LEARNING RESOURCES CENTER
BUILDING 'D' AND 'CR' REMODEL

VENTURA COLLEGE

September 24, 2001
KBZ Job No. 93-18

INSPECTOR COPY

ER-08
 SHEET E-601

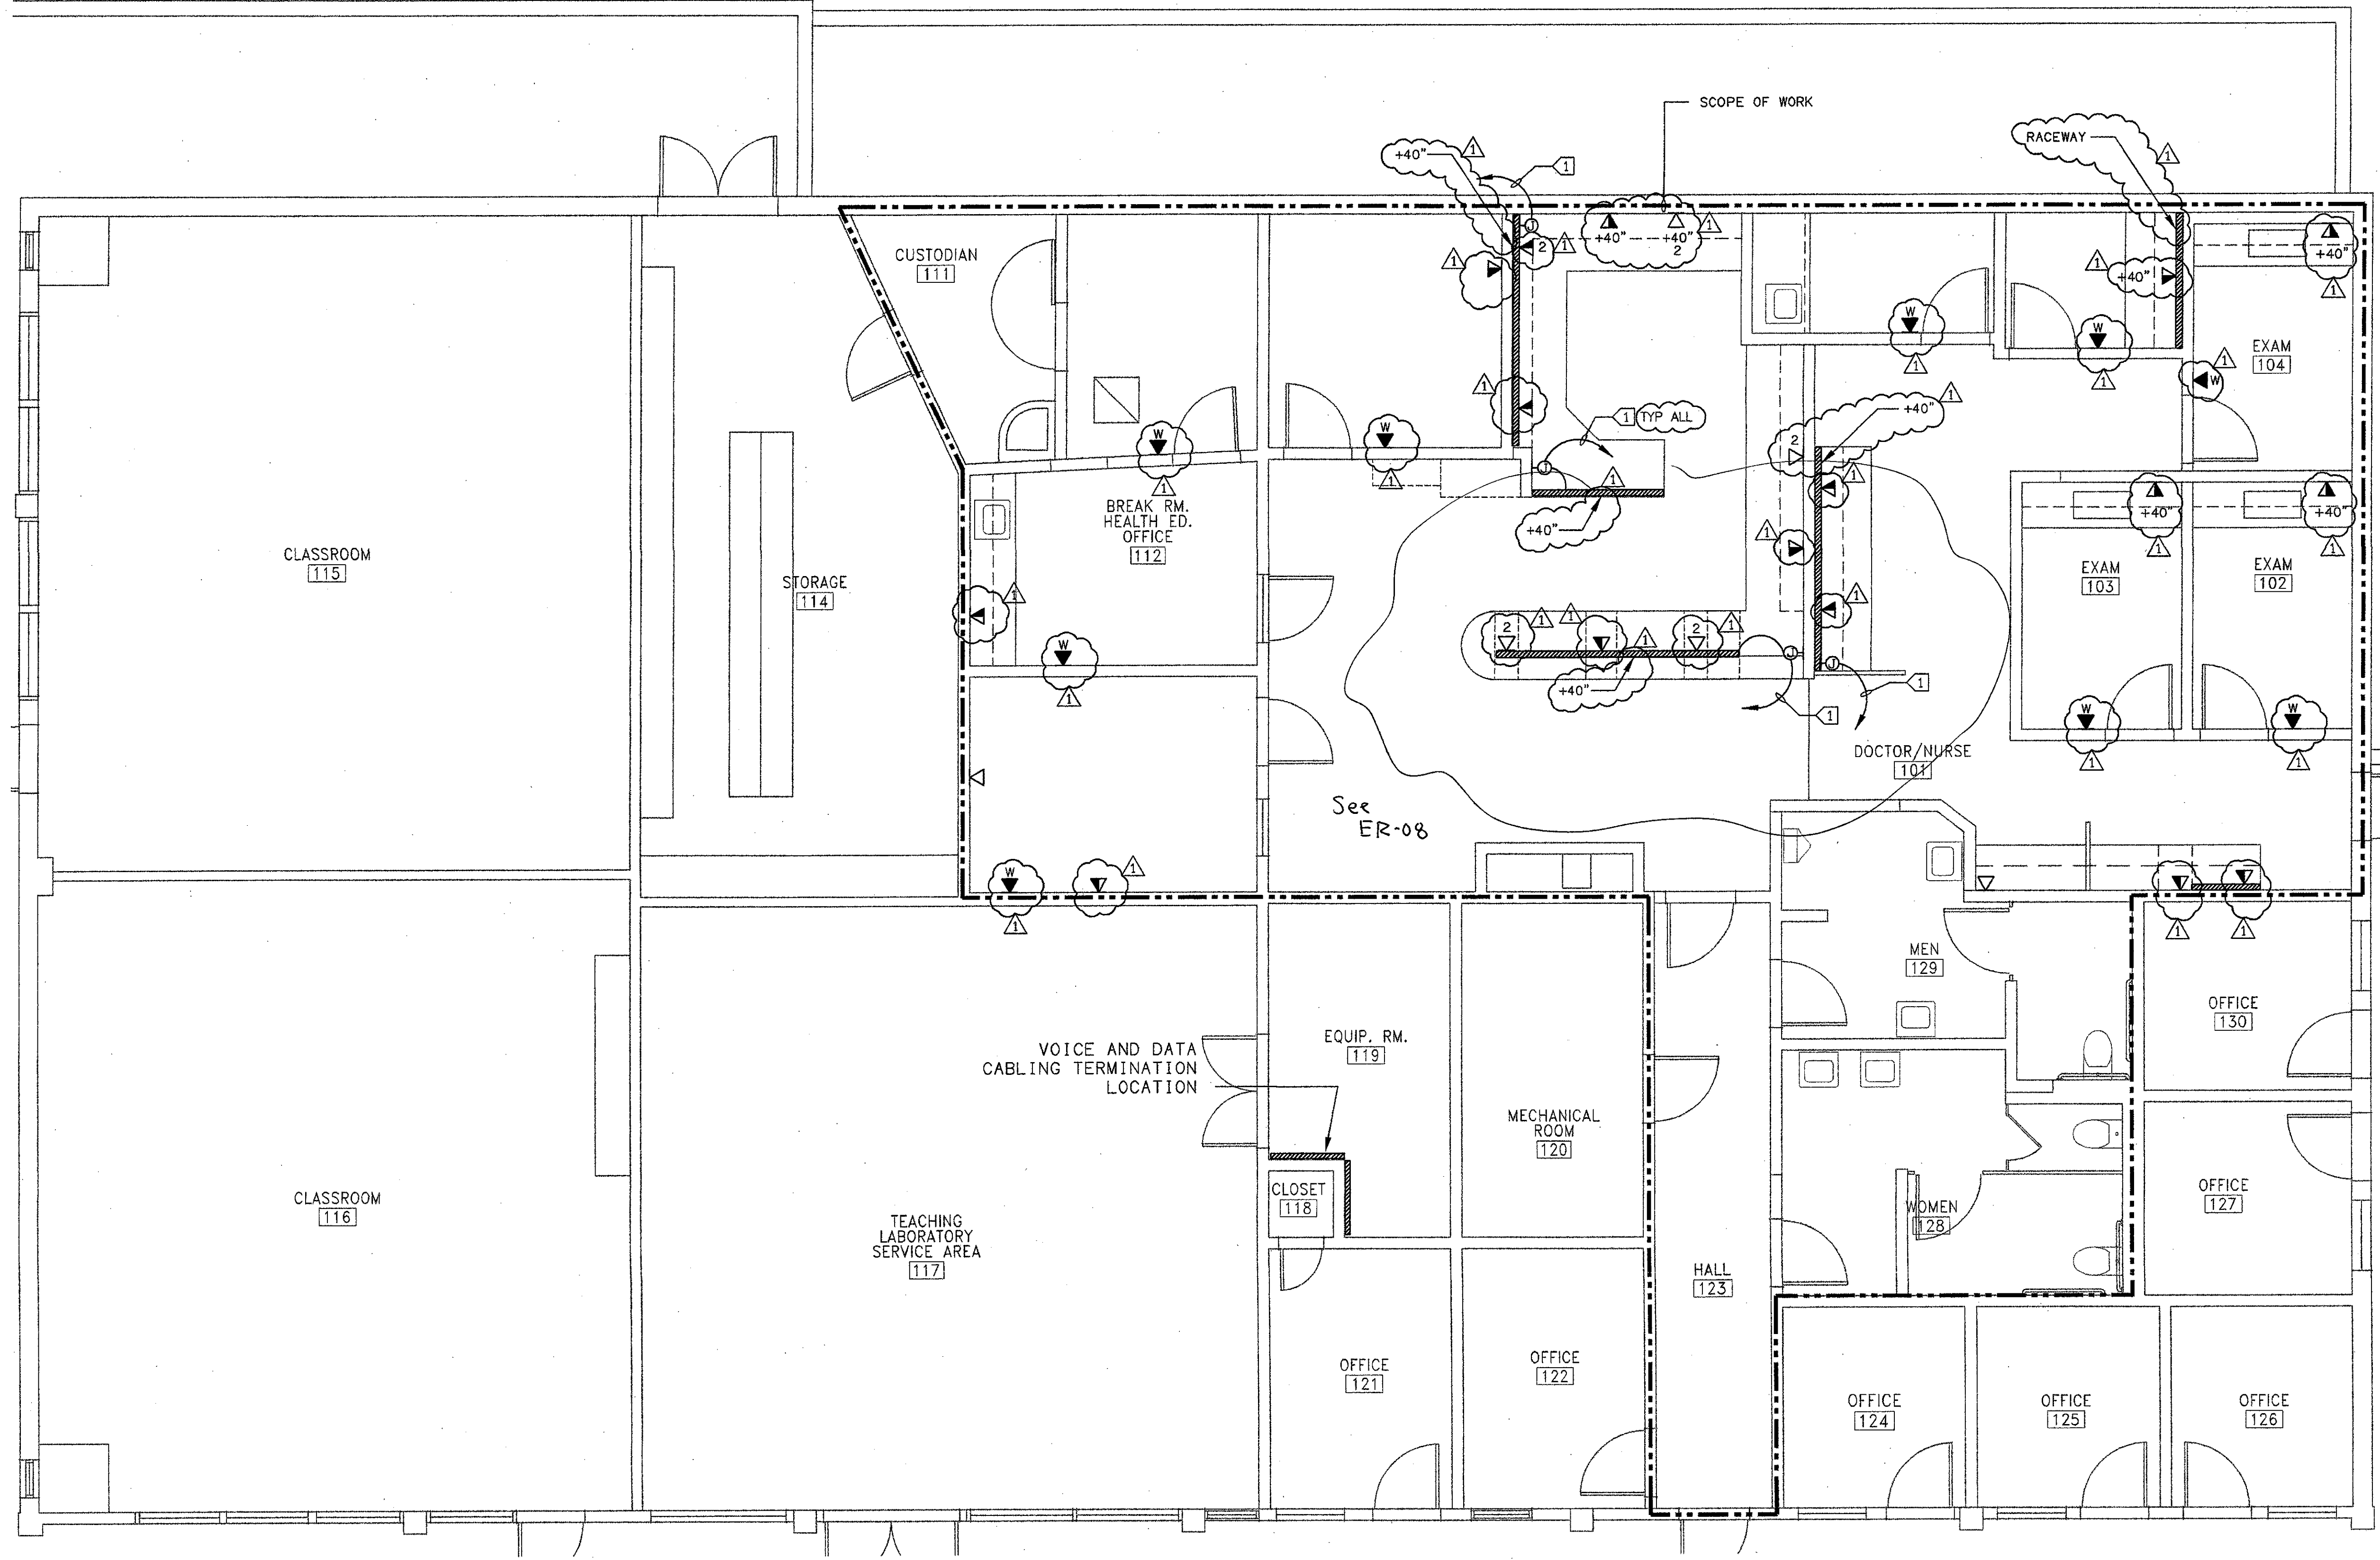
ITEM 12. Drawing Sheet E-601: *Appendum 2*

a. Power and communication raceways shall be provided as shown on drawing E-402.
